**BROWNS FERRY NUCLEAR PLANT (BFN) - UNIT 3 - REPLY TO NRC
REQUEST FOR ADDITIONAL INFORMATION (RAI) REGARDING AUGMENTED
REACTOR VESSEL WELD EXAMINATION (TAC NO. M91786)**

TENNESSEE VALLEY AUTHORITY
BROWNS FERRY NUCLEAR PLANT (BFN)
UNIT 3

TVA REPLY TO NRC REQUEST FOR ADDITIONAL INFORMATION
REGARDING AUGMENTED REACTOR VESSEL WELD EXAMINATION

BROWNS FERRY UNIT-3 ID EXAMINATION

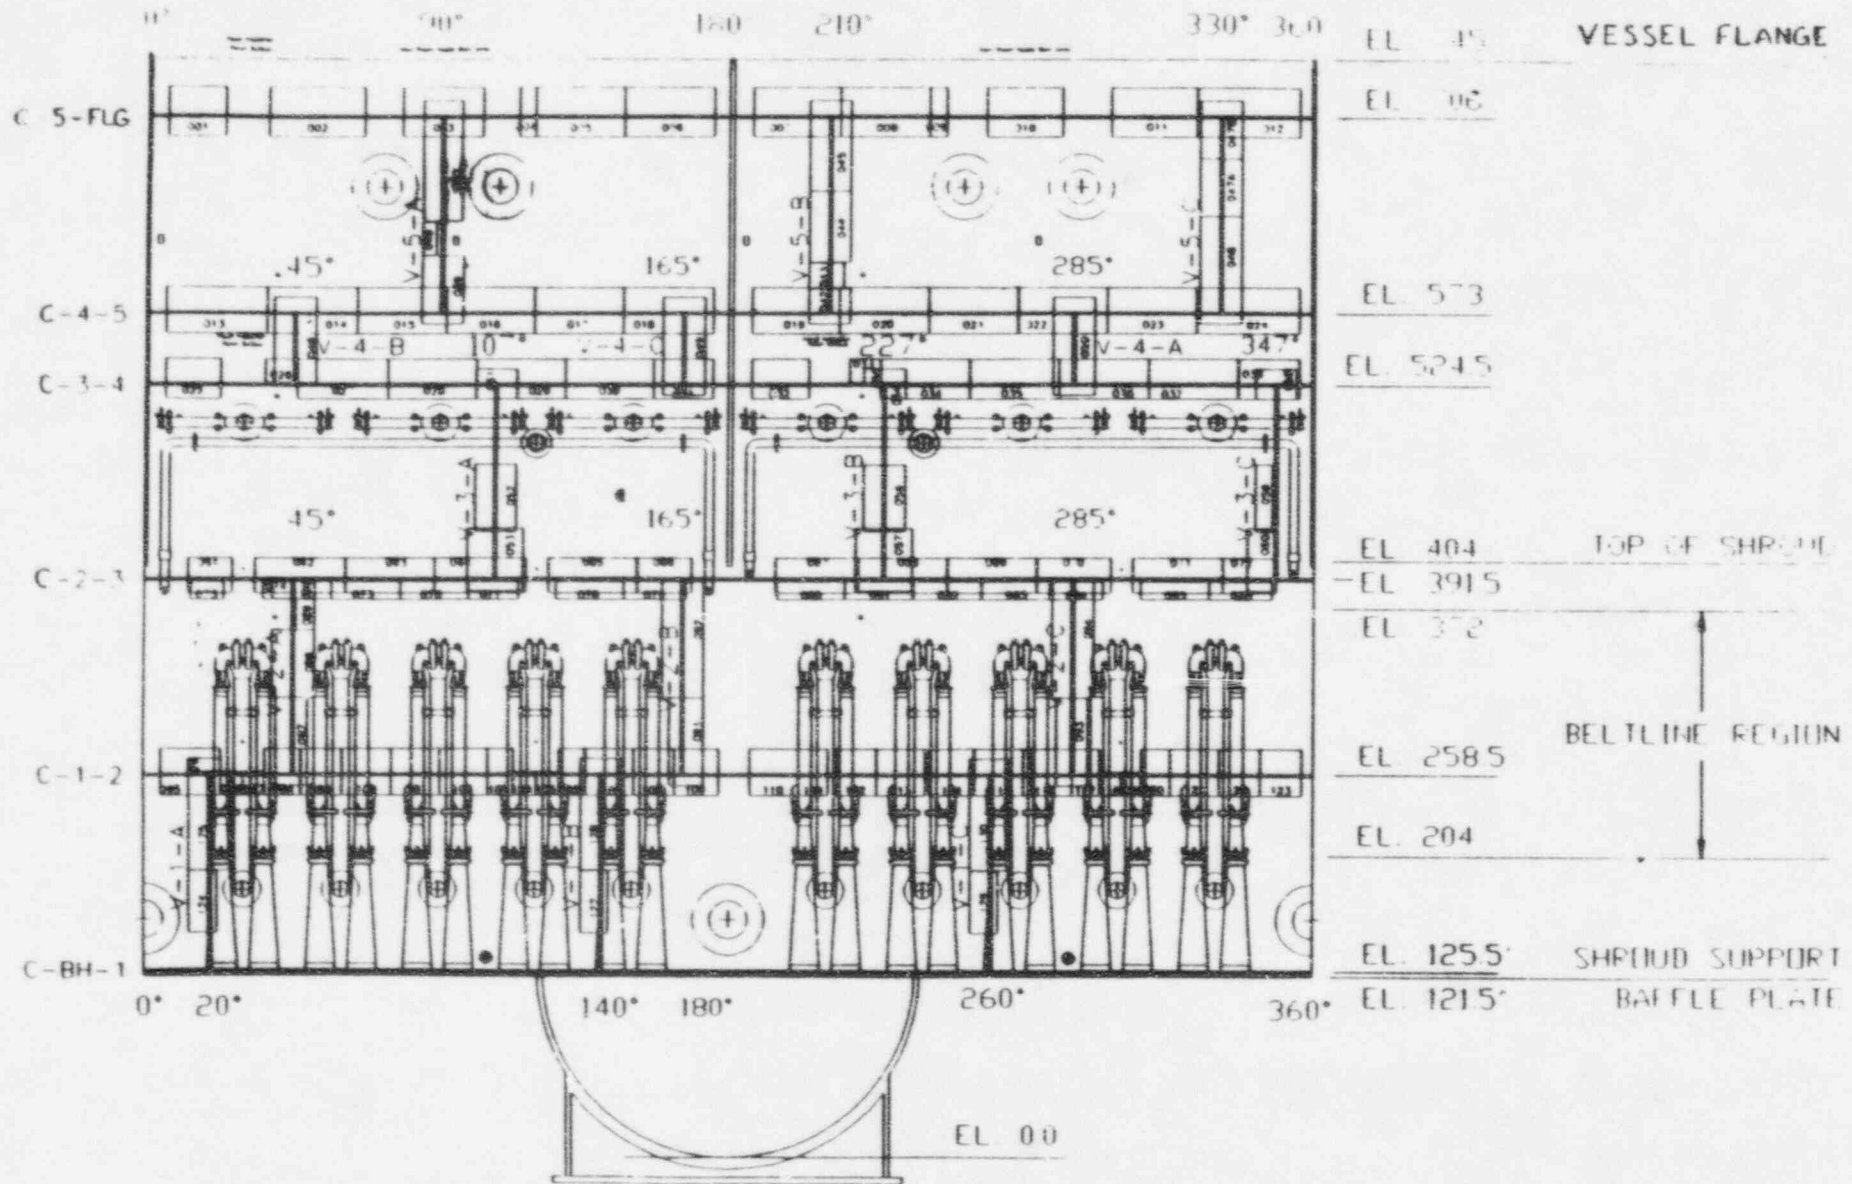
Longitudinal RPV Shell Welds (See Attachment 1)

V-1-A: 82 percent
V-1-B: 83 percent
V-1-C: 88 percent
V-2-A: 85 percent
V-2-B: 90 percent
V-3-C: 70 percent
V-4-B: 83 percent

The remaining ten RPV shell welds received "essentially 100%" examinations ranging from 91 percent to 100 percent coverage:

C-4-5: 93 percent
C-3-4: 97 percent
V-2-C: 91 percent
V-3-A: 99 percent
V-3-B: 99 percent
V-4-A: 100 percent

V-4-C: 100 percent
V-5-A: 100 percent
V-5-B: 99 percent
V-5-C: 100 percent
